## Planning Commission Draft Motion

*Hearing Date:* September 30, 2010  
*Case No.:* 2005.0963E  
*Project:* Crystal Springs Pipeline No. 2 Replacement Project  
*Zoning:* Various  
*Block/Lot:* Various  
*Project Sponsor:* San Francisco Public Utilities Commission  
1145 Market Street, 5th Floor  
San Francisco, CA 94103  
*Staff Contact:* Brett Becker – (415) 575-9045  
[brett.becker@sfgov.org](mailto:brett.becker@sfgov.org)

### ADOPTION OF FINDINGS RELATED TO THE CERTIFICATION OF A FINAL ENVIRONMENTAL IMPACT REPORT FOR THE PROPOSED CRYSTAL SPRINGS PIPELINE NO. 2 REPLACEMENT PROJECT.

**DATE:** September 23, 2010  
**TO:** President Miguel and Members of the Planning Commission  
**FROM:** Brett Becker, Environmental Planner  
**RE:** Errata for Comments and Responses document for the Environmental Impact Report for SFPUC's Crystal Springs Pipeline No. 2 Replacement Project (File No. 2005.0963E) Issued on September 8, 2010

**Figure 1-1: History of Work Performed for the CSPL No. 2 Replacement Project**

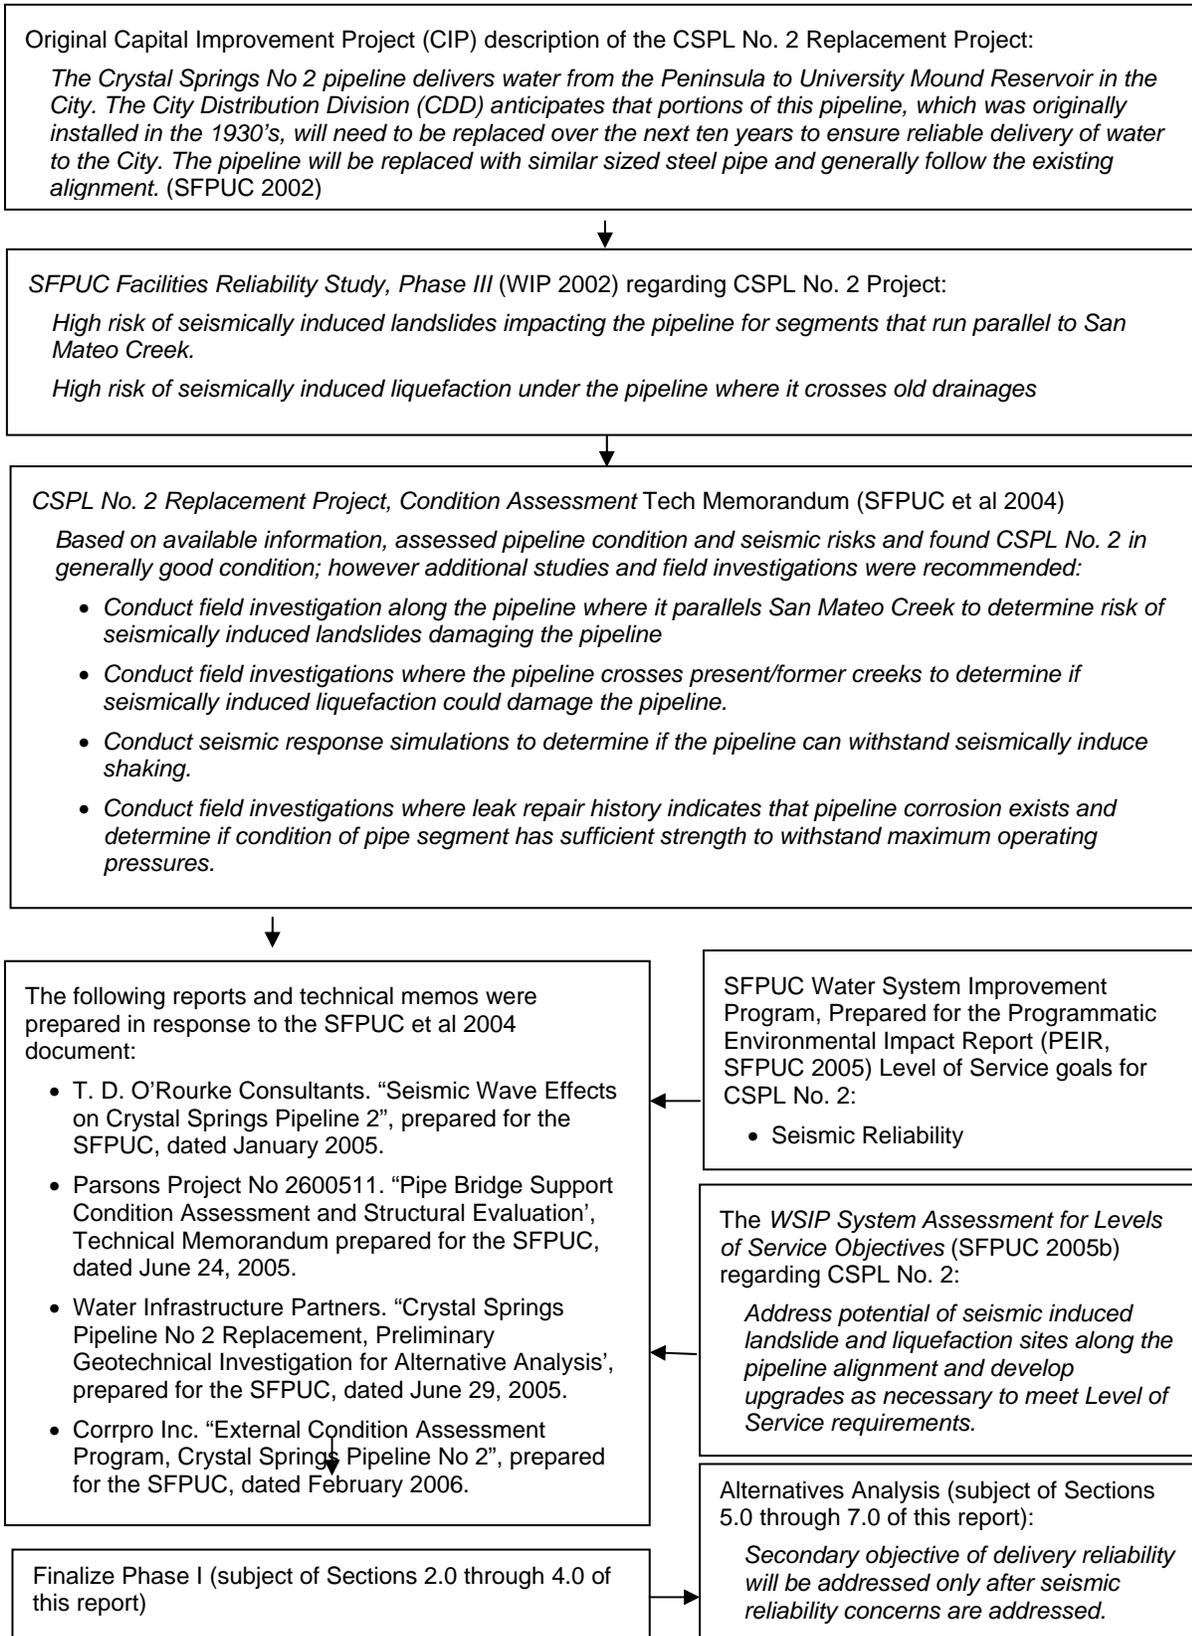
**Summary of Specific Comment:** Mr. Lawrence expresses his disagreement with the response to his comment [P2] on pp. 3-7 and 3-8 of the C&R document. Mr. Lawrence indicated that his understanding is that the CSPL2 Replacement Project described in the SFPUC 2002 Capital Improvement Program included replacement of the entire CSPL2.

**Response:** To clarify, as described in response P2 of the C&R document and in the CSPL2 Replacement Project Alternatives Analysis Report (Parsons, 2006<sup>1</sup>), the original Capital Improvement Project (CIP) description of the CSPL2 Replacement Project is as follows: "The City Distribution Division (CDD) anticipates that portions of this pipeline, which was originally installed in the 1930's, will need to be replaced over the next ten years to ensure reliable delivery of water to the City. The pipeline will be replaced with similar sized steel pipe and generally follow the existing alignment (SFPUC, 2002)." [emphasis added] Relevant excerpts of this report are included as Attachment B; Figure 1-1 describes the history of work performed to finalize the CSPL2 project.

**Figure 3.5**  
**Detailed Construction Work Areas:**  
**Sites 4, 5, 6, 7**  
 Crystal Springs Pipeline No. 2 Replacement Project  
 San Mateo County, California

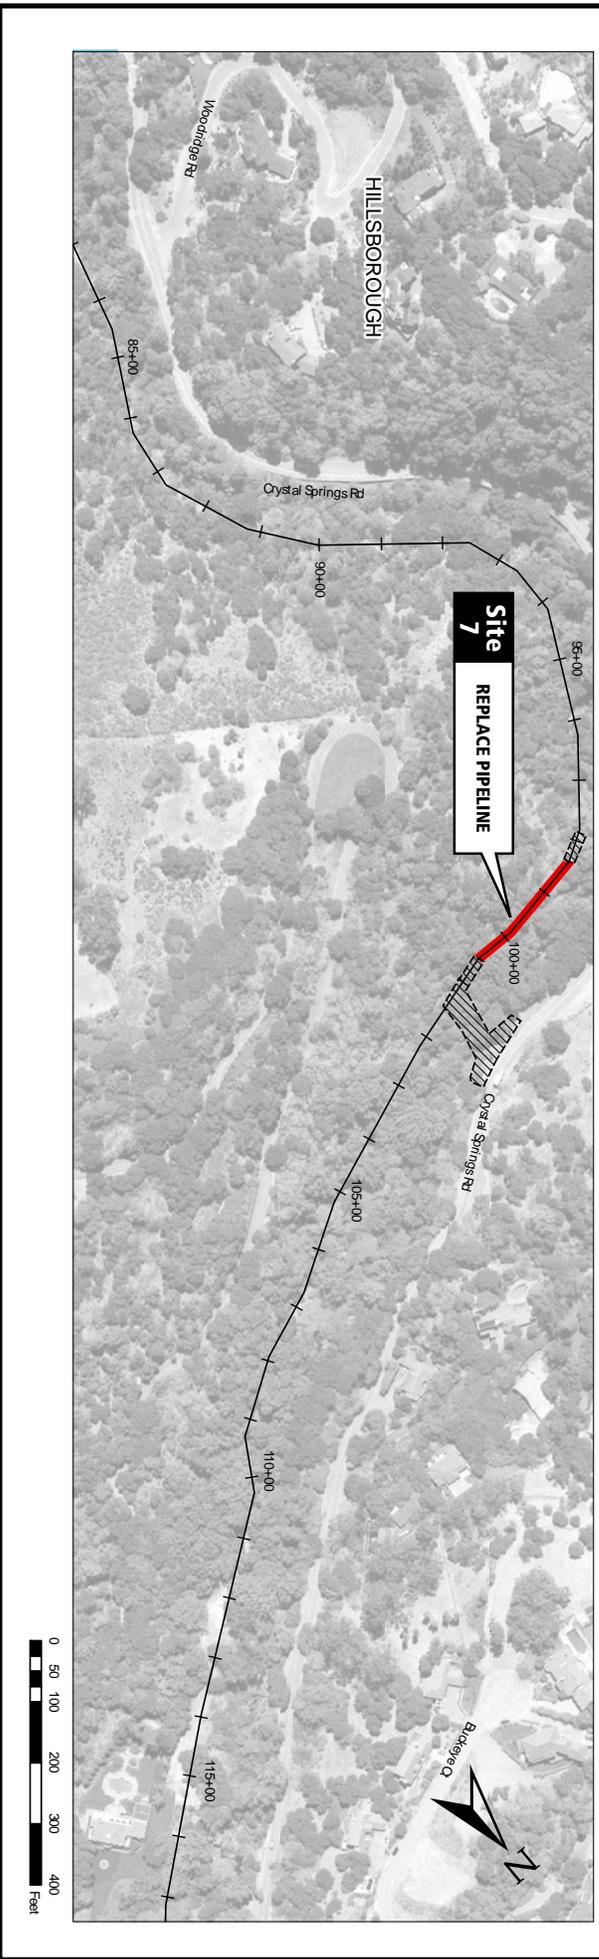
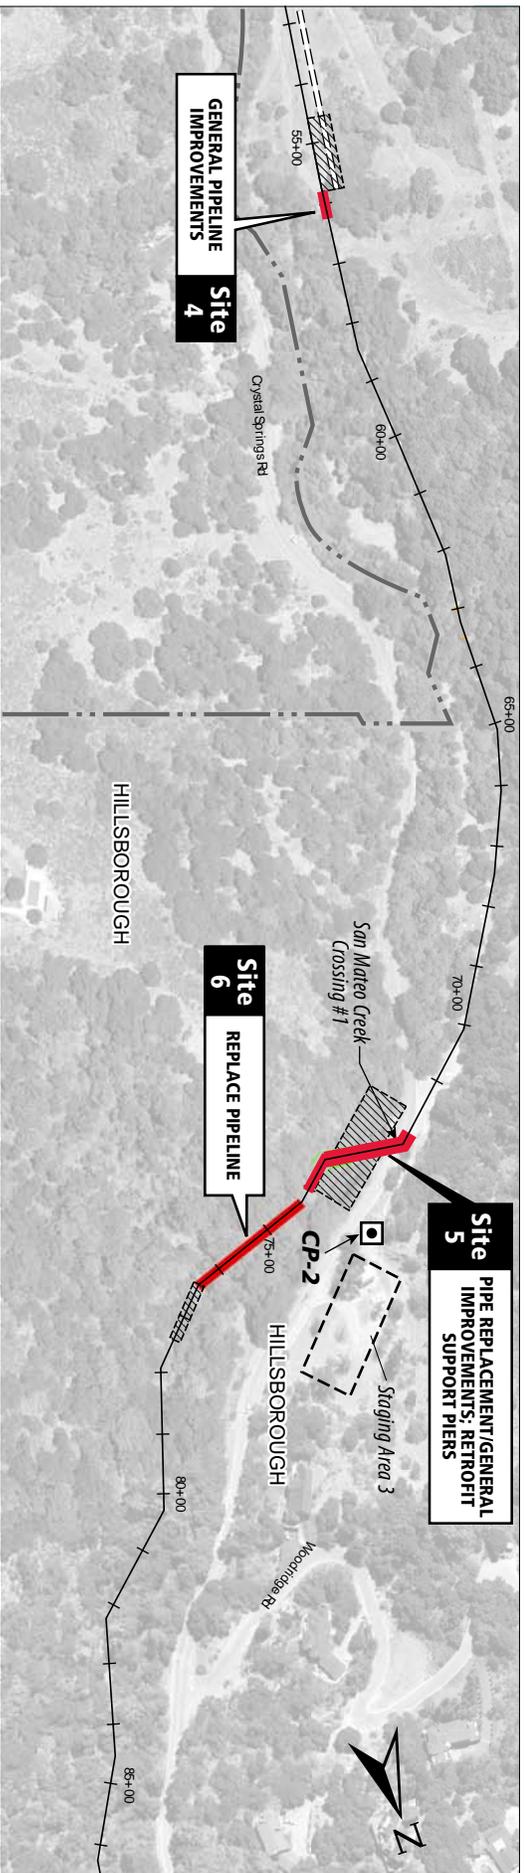
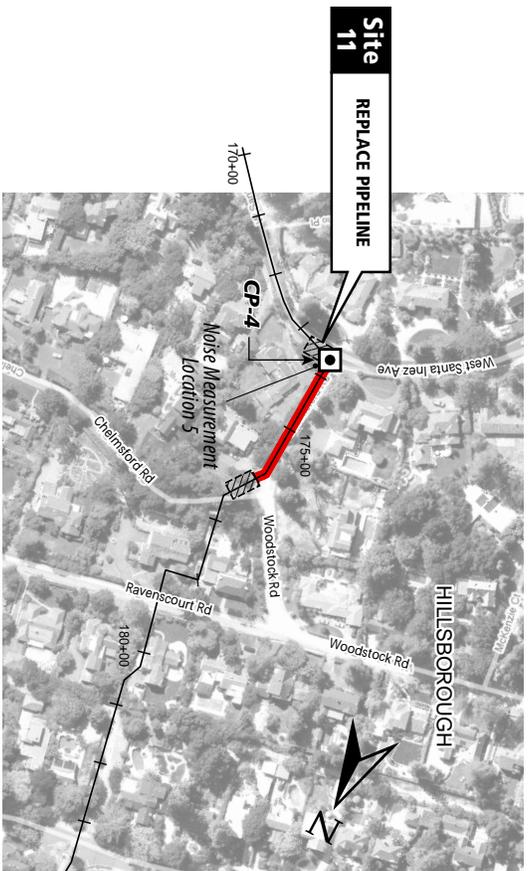
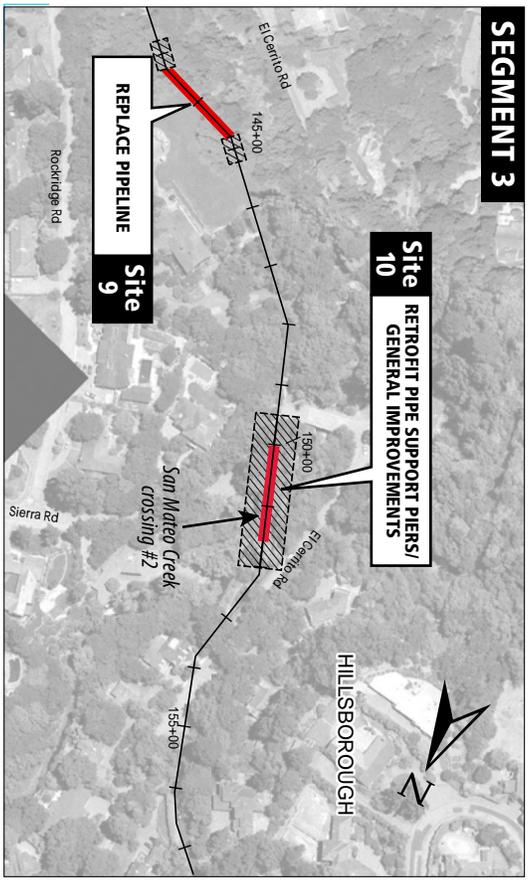
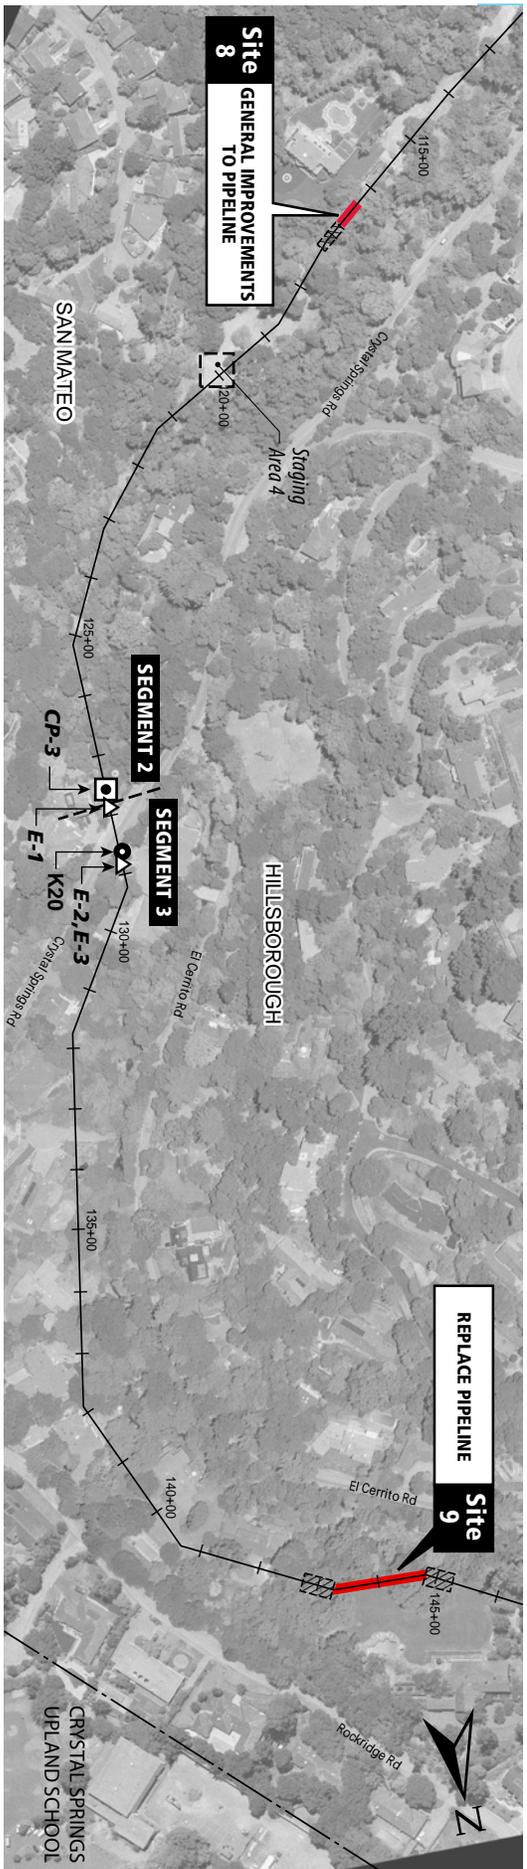
On pages 3-6 and 3-7, Figure 3.5 and Figure 3.6 are revised to reflect the removal of Variant 1 from the project, as shown on the following pages.

**Figure 5.11-3**

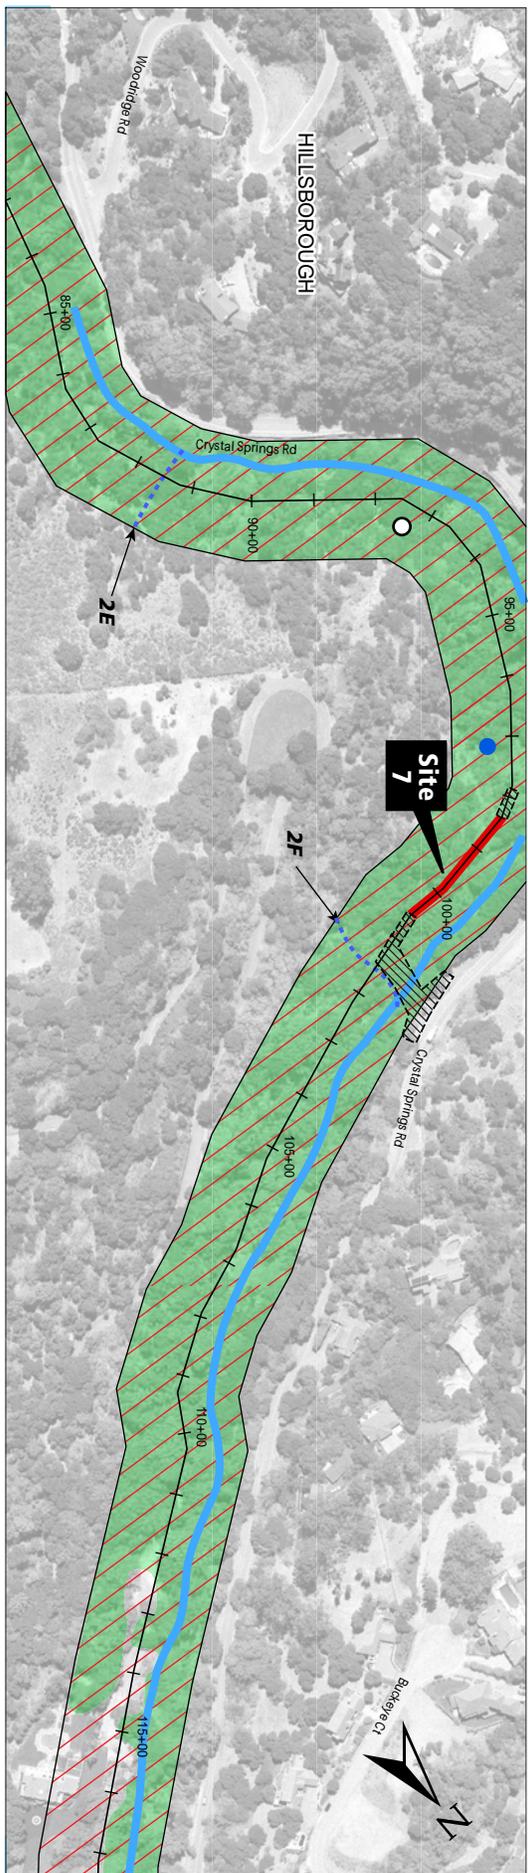
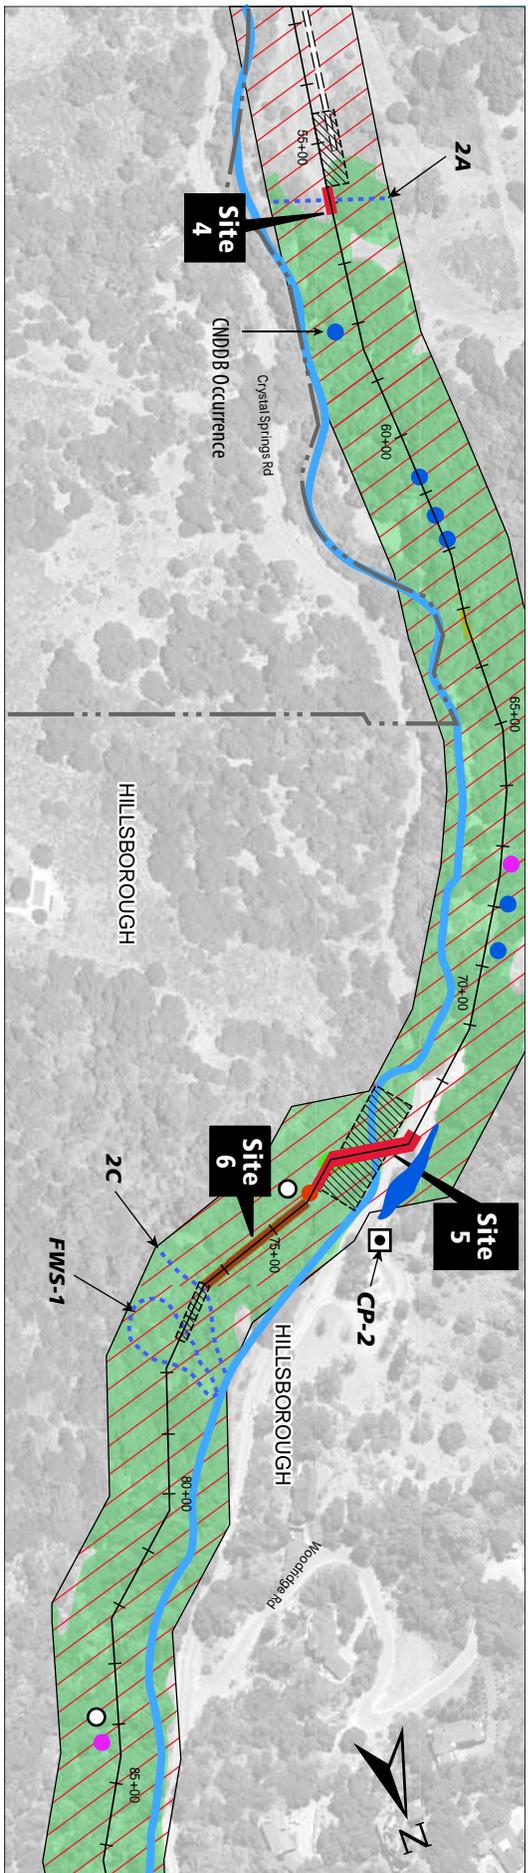
On pages 5.11-18 and 5.11-19, Figure 5.11-3 and Figure 5.11-4 have been revised to reflect the removal of Variant 1 from the project, as shown on the following pages.
